ADDENDUM #3

Project	Nelson H.S. Renovations	Project No.	2323
Location	4181 New Street, Burlington, Ontario	Date of Issue	2024 05 31
Owner	The Halton District School Board	File	2323/7.1.3

This Addendum forms part of the Contract Documents and amends the original Drawings and Specifications, dated 2024 05 13, as noted below.

2 SECOND FLOOR PARTIAL RENOVATION PLAN (MUSIC ROOMS AND MECH. ROOMS)
A212 1:100

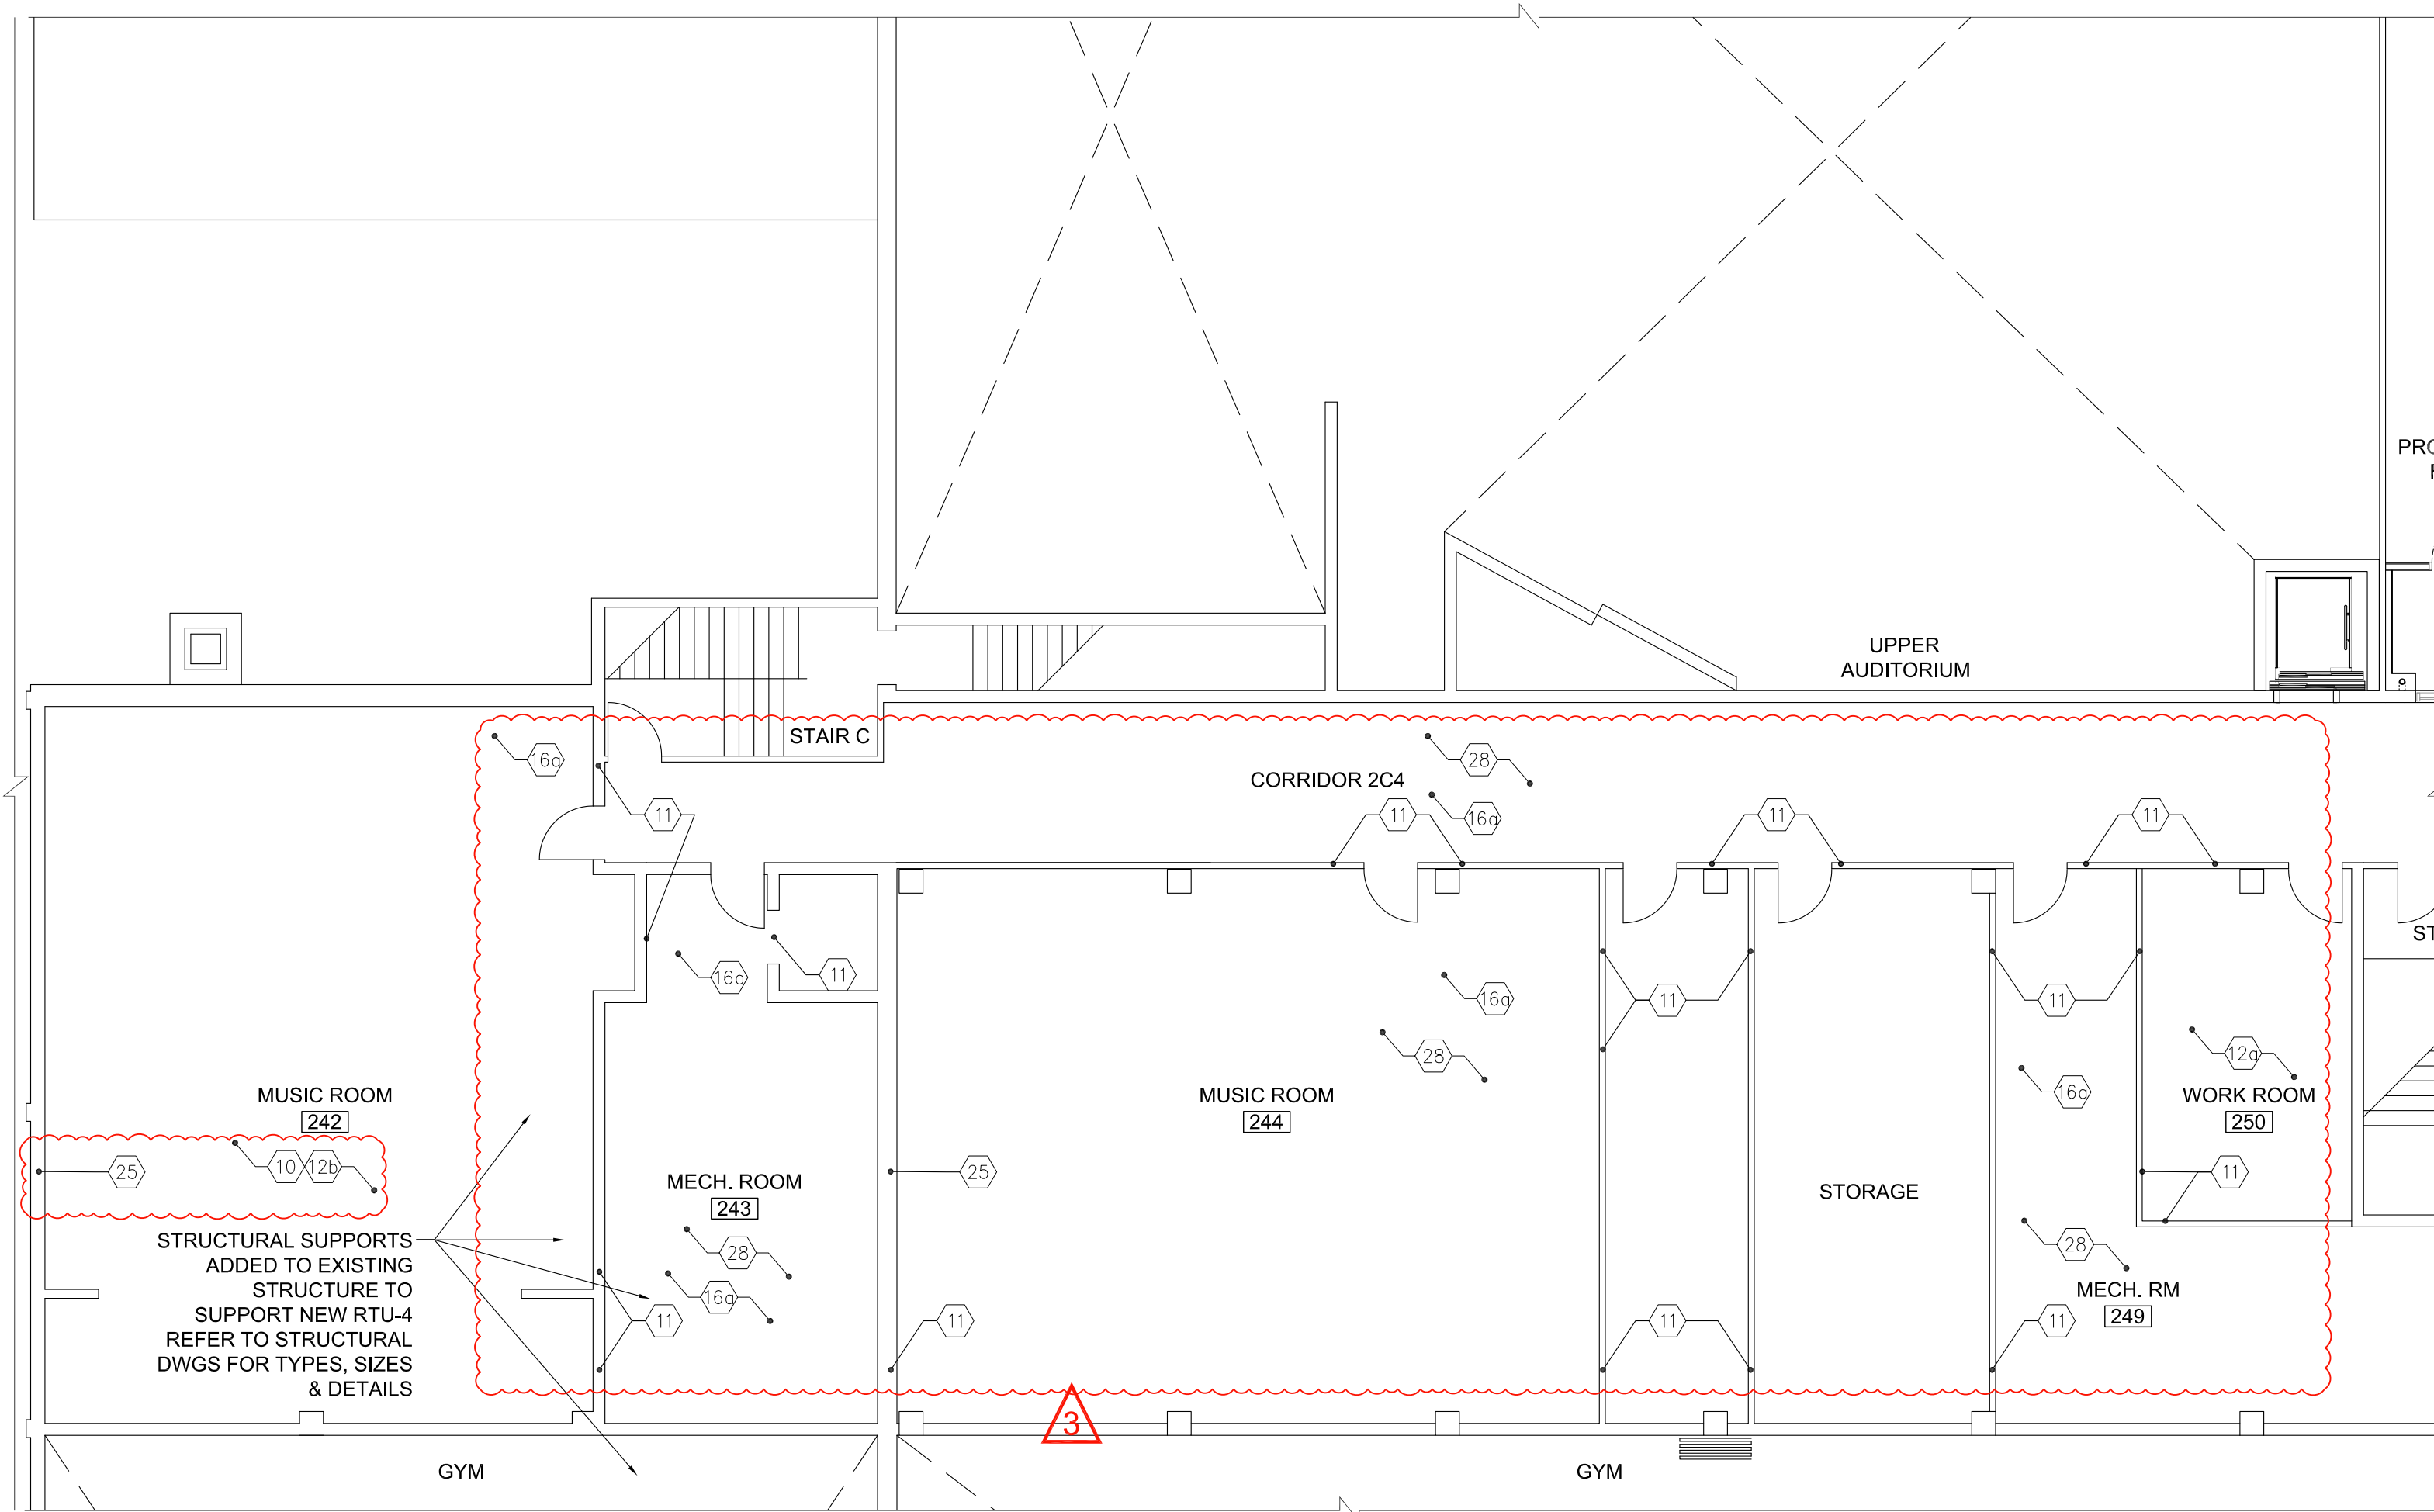
A3-6 DRAWING A212 SECOND FLOOR PARTIAL RENOVATION PLANS (reissued)

- .2 Add Fire Rating Notes and Fire Proofing Notes
- .3 Replace Renovation note no. 3 and 18
- .4 Add Renovation note no. 9a, 16a, 24, 25, 26, 27 and 28
- .5 Add Renovation note no. 11 in Rms.
- .6 Add Renovation note no. 16a in Rms.

**ROOF PARTIAL
RENOVATION PLAN**

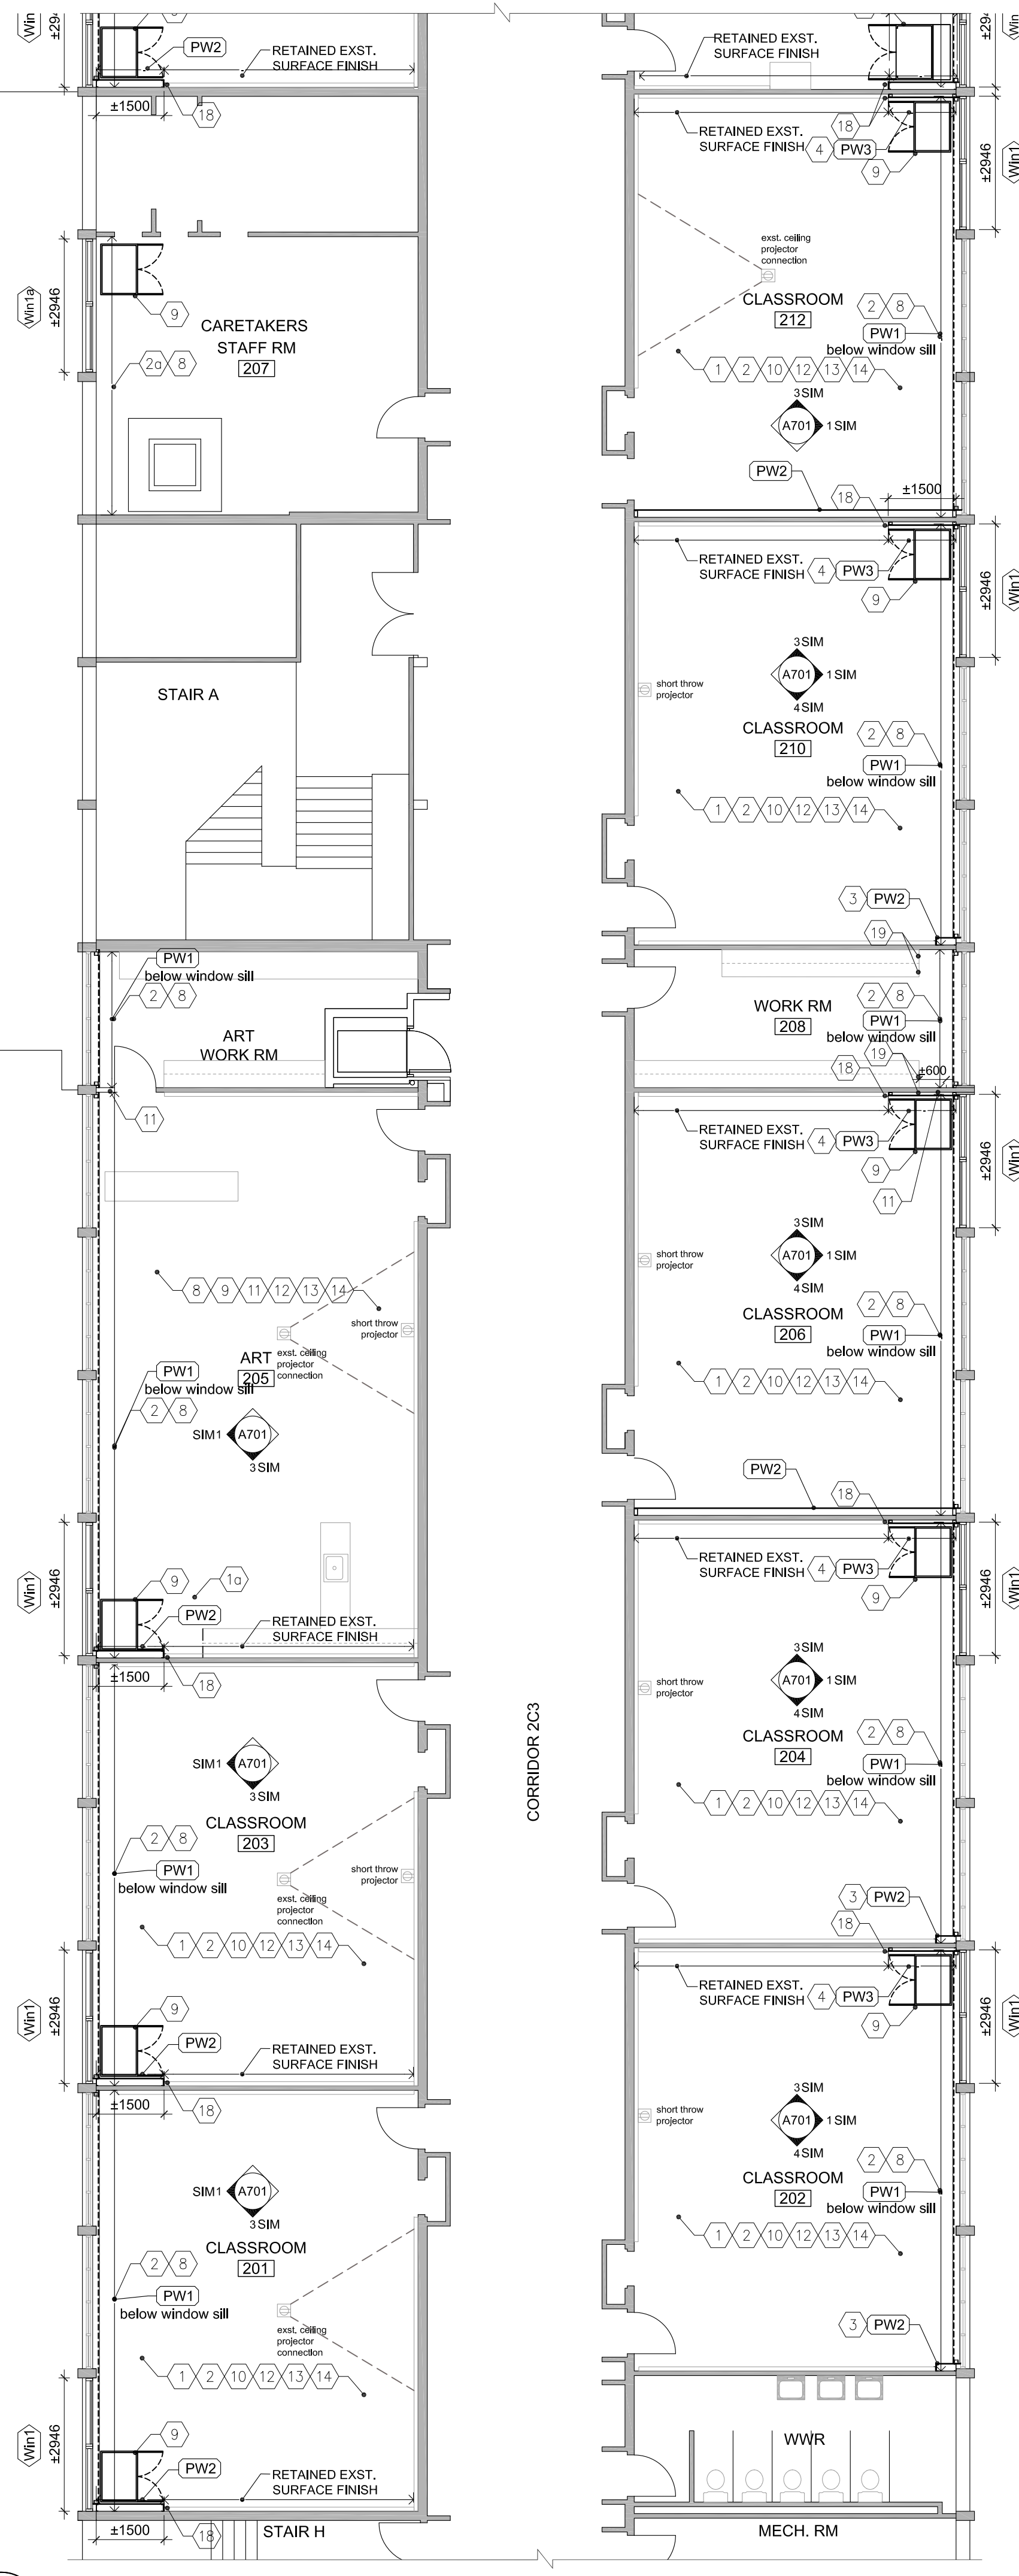
A3-7 DRAWING A213 ROOF PARTIAL RENOVATION PLANS (reissued)

- .1 Replace drawing with re-issued drawing
- .2 Revise new roof patchwork scope for RTU-1, RTU-2, RTU-3, RTU-4 and RTU-5
- .3 Add reference detail notes and tags to refer to drawing A502 Roof Section Details
